TOLEDO - LUCAS COUNTY PLAN COMMISSIONS

REF: SUP-6006-23

SUBJECT: Amendment to Special Use Permit Originally Granted by Ord. 366-78 and Ord. 595-85 for Gas Station Expansion

SITE PLAN

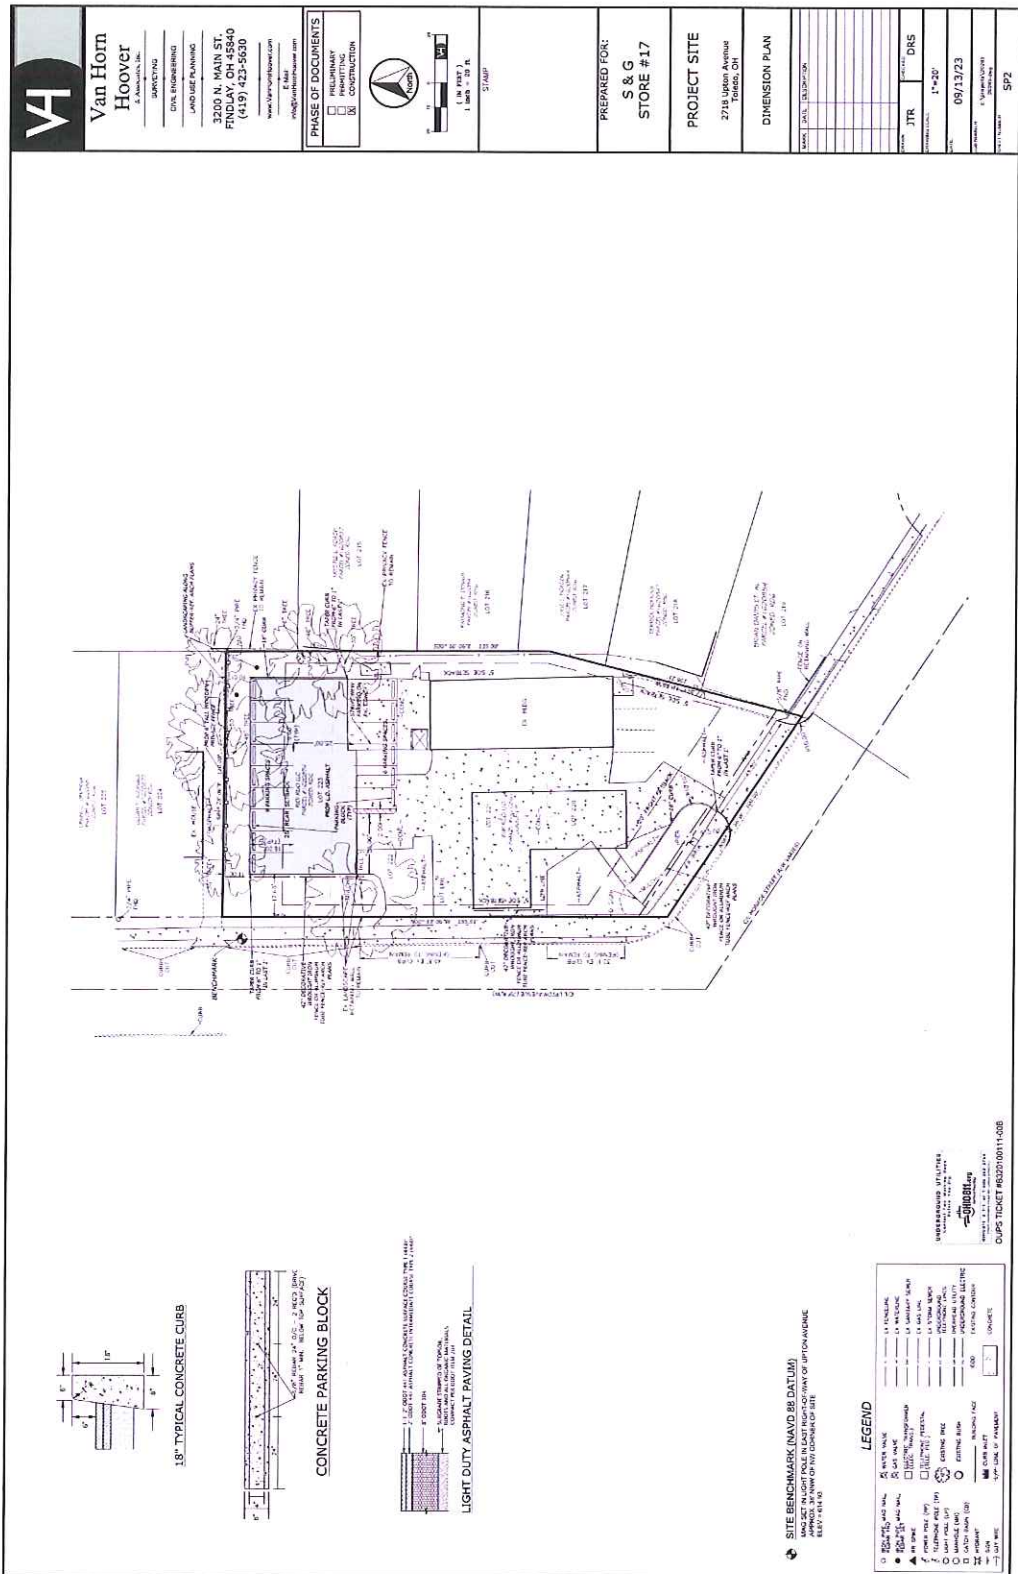
Pursuant to TMC§1107.0304 – *Parking, Loading, and Access*: Gasoline and Fuel sales are required to have one (1) parking space per pump plus one (1) per three-hundred (300) square feet of building area. The site plan shows three (3) gas pumps on site. Six (6) at pump parking spaces are required. The proposed building covers an area of 2,300 square feet requiring an additional eight (8) parking spaces. A total of fourteen (14) parking spaces are required for this site. The submitted site plan shows fifteen (15) parking spaces to the north of the site for the gasoline and fuel sales use. TMC§1107.1601 requires one stacking space for every gasoline pump island. The stacking spaces must be a minimum of ten feet (10') by twenty feet (20') in size.

A portion of the total number of required off-street parking spaces must be specifically designated, located, and reserved for use by persons with physical disabilities. According to the table in TMC§1107.1701 – *Number of Required Parking Spaces for Persons with Disabilities*, the applicant is required to provide at least one (1) van accessible space with an eight-foot (8') drive aisle for persons with physical disabilities. At least one (1) van accessible parking space with an eight-foot (8') drive aisle shall be provided on a revised site plan for the gasoline and fuel sales use.

Additionally, one (1) bicycle parking per ten (10) parking spaces is required for the convenience store use. Two (2) bicycle parking spaces are required. This is not acceptable as depicted on site plan received on November 8, 2023. Two bicycle parking spaces shall be shown on a revised site plan.

16. Bicycle parking slots shall be provided pursuant to Off-Street Parking Schedule "A," (TMC§1107.0300). Minimum number of bicycle parking slots required for a convenience store is one (1) bicycle parking per ten (10) parking spaces. Two (2) bicycle parking spaces are required. **Not acceptable as depicted on site plan received on November 8, 2023. Two bicycle parking spaces shall be shown on a revised site plan.**

17. Any spaces reserved for the use by persons with physical disabilities shall adhere to the standards outlined in TMC§1107.1700. One (1) van accessible space with an eight-foot (8') drive aisle is required. **Not acceptable as depicted on site plan submitted November 8, 2023.**
